Notice Inviting Tender:

For IIM (Metal House) at AQ-13/4, Sector-V, Salt Lake City, Kolkata-91

(IIM Mural Rectification Work - Auditorium and External Front & Side Facade)

IIM Mural Rectification Work - Auditorium and External Front & Side Facade

B. Front Facade Mural- Annexure II

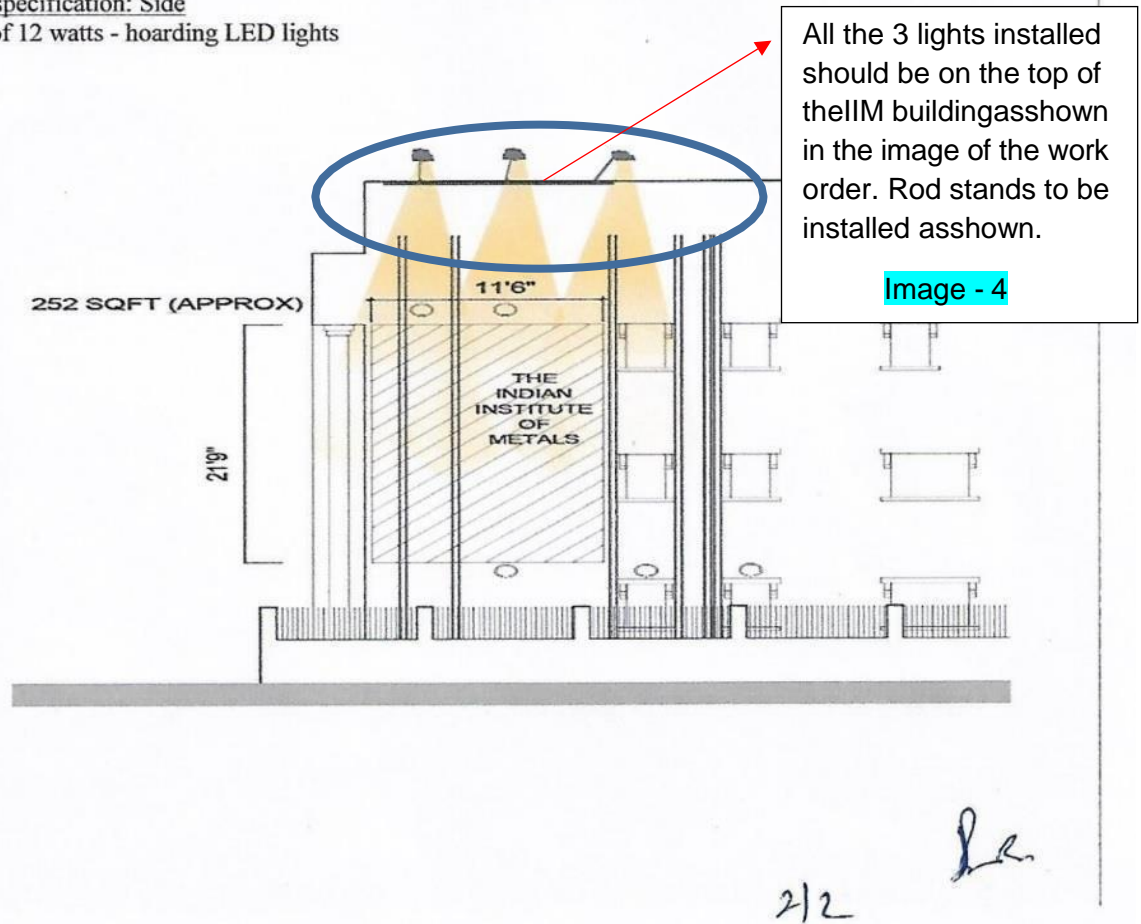
- 1) The central circular piece to be removed. (Refer Image 1)

Image 2

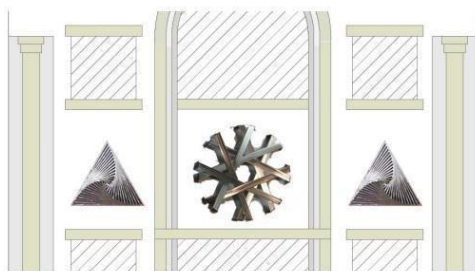
For the central circular piece (8 nos. of interlocking hollow square section) to be installed as shown in the image below. (Refer Image 2)

8 no.s of interlocking hollow square sections of light weight alloy coated for weather proofing

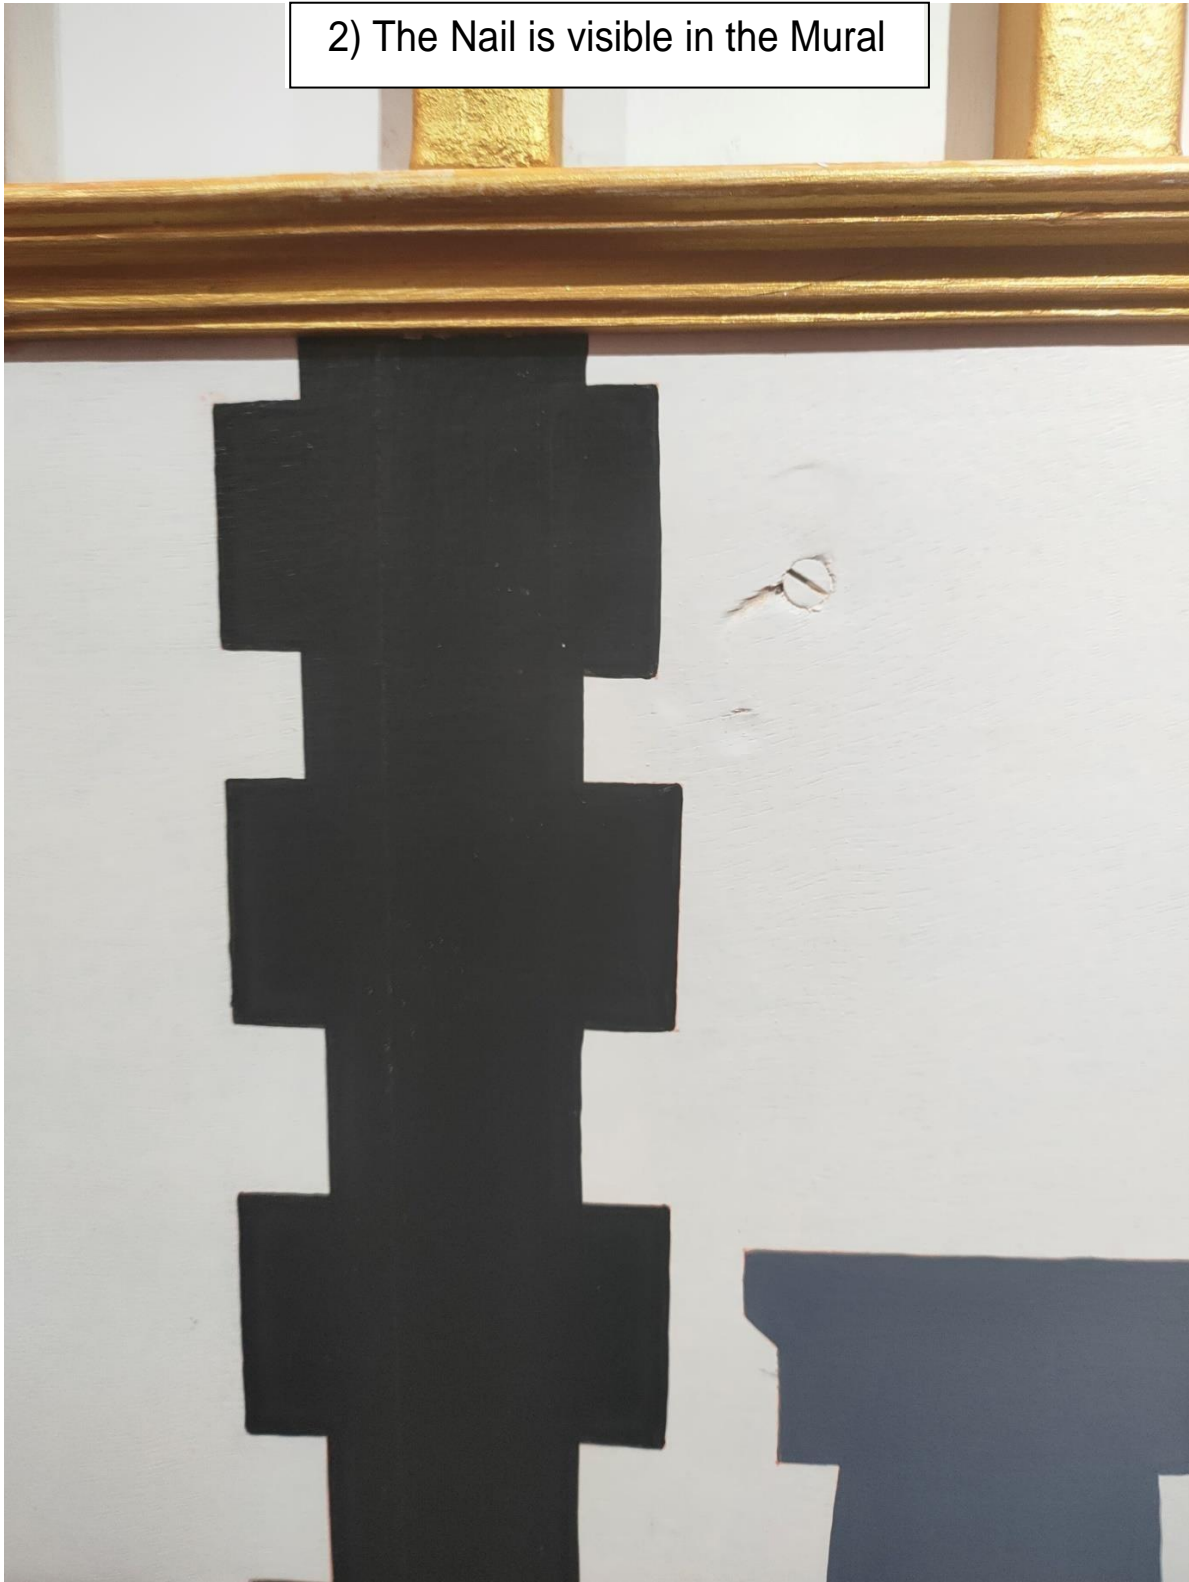
2) The Nail is visible in the Mural

3) Joint on the Mural is visible.
Has an irregular edge.

4) Joint on the Mural is visible.
Has an irregular edge.

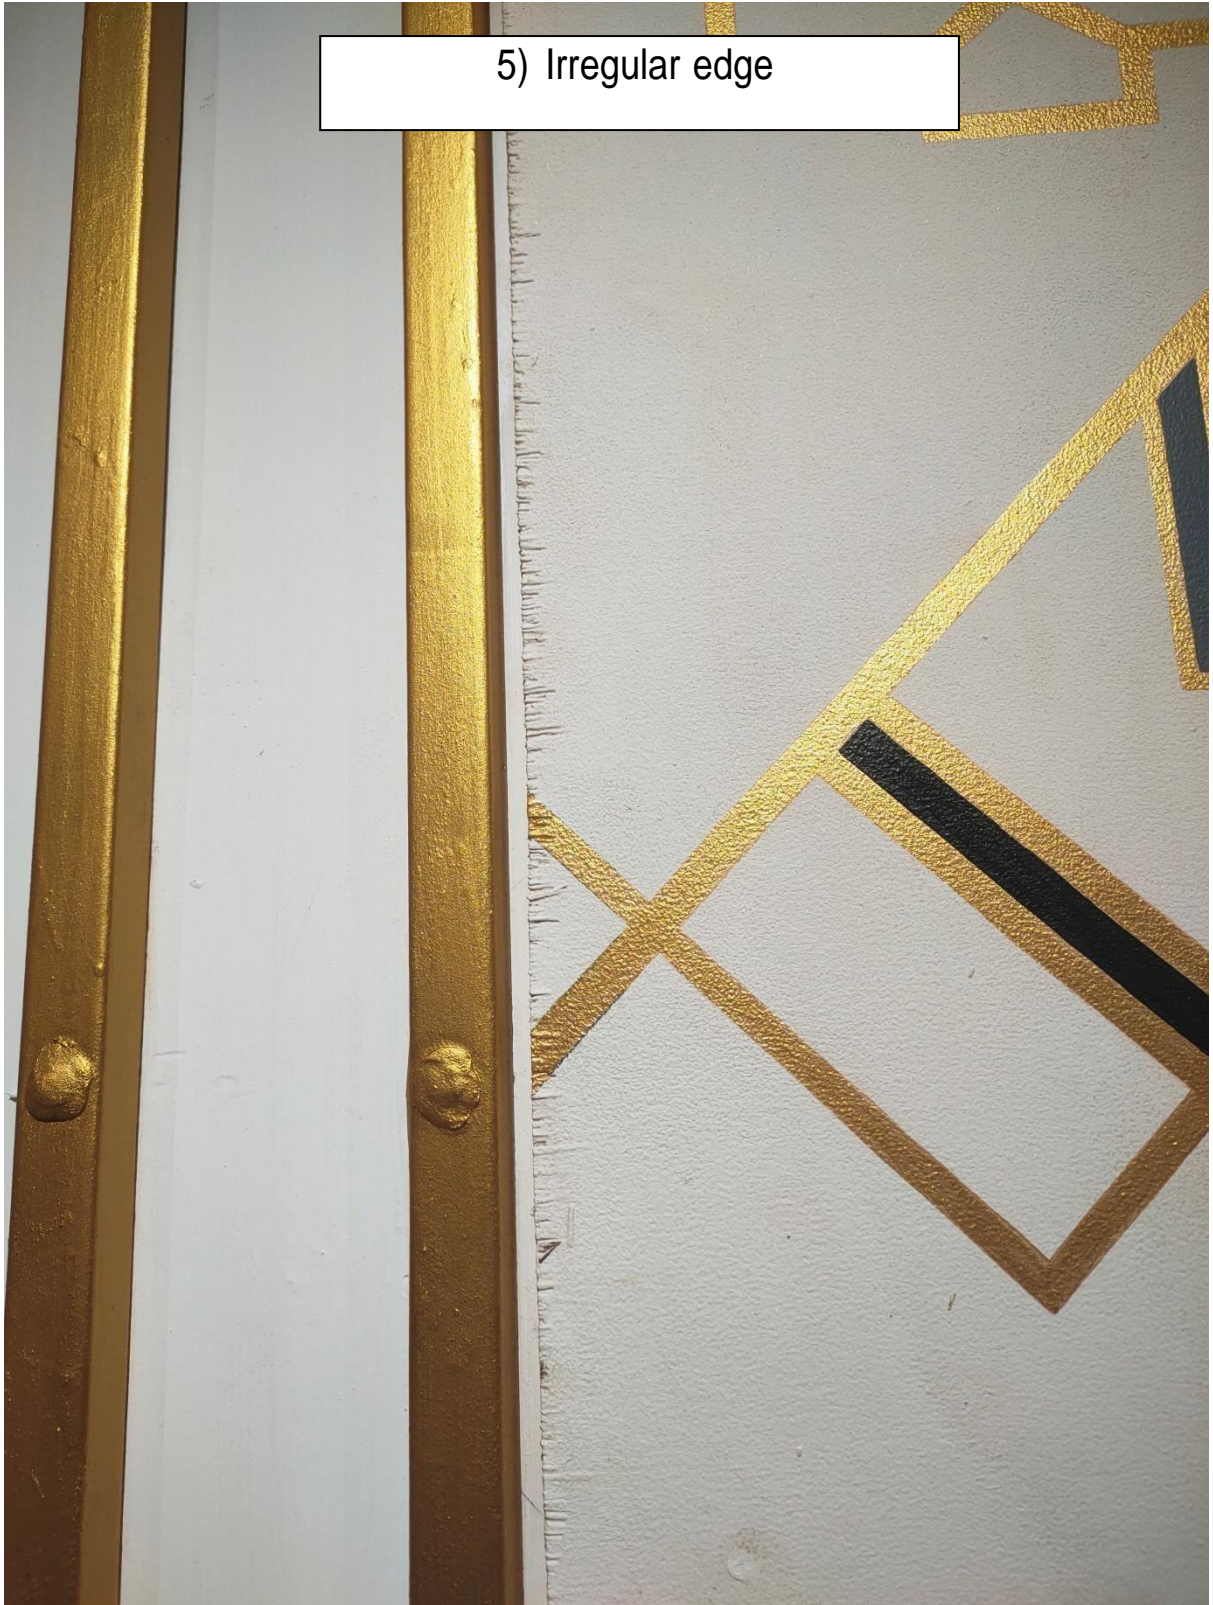
5) Irregular edge

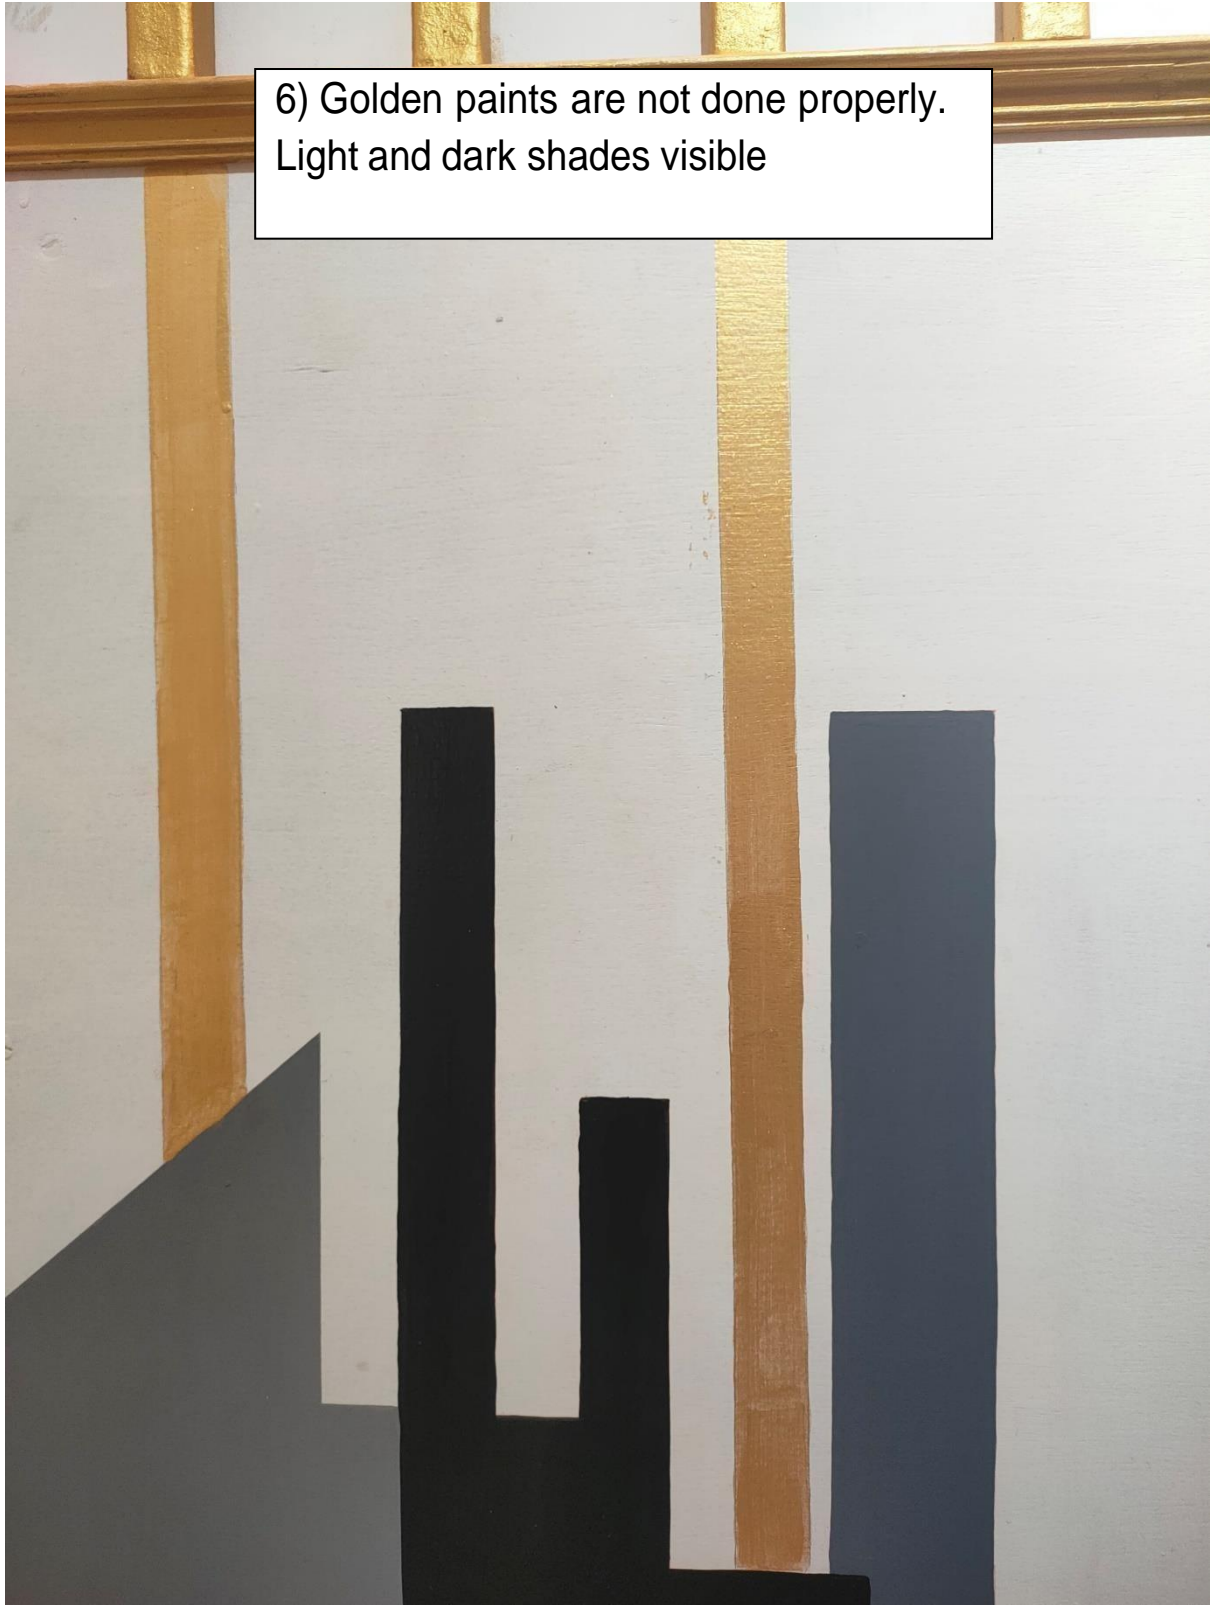
6) Golden paints are not done properly.
Light and dark shades visible

7) Dirt on the mural. Nail Visible

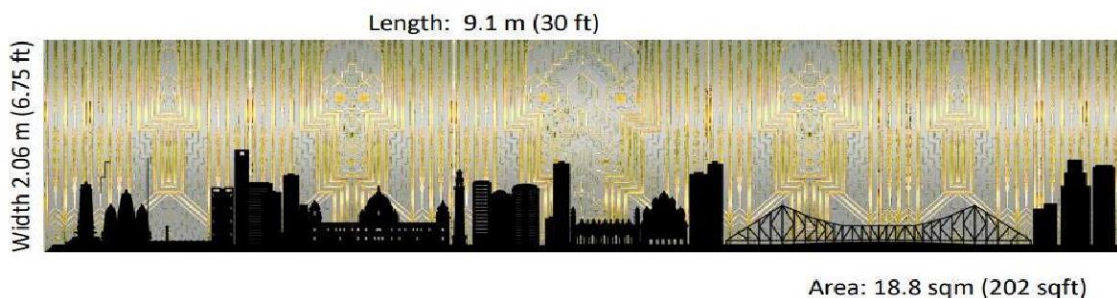
8) Golden painting is not done properly.
Light and dark shades are visible all
over the mural.
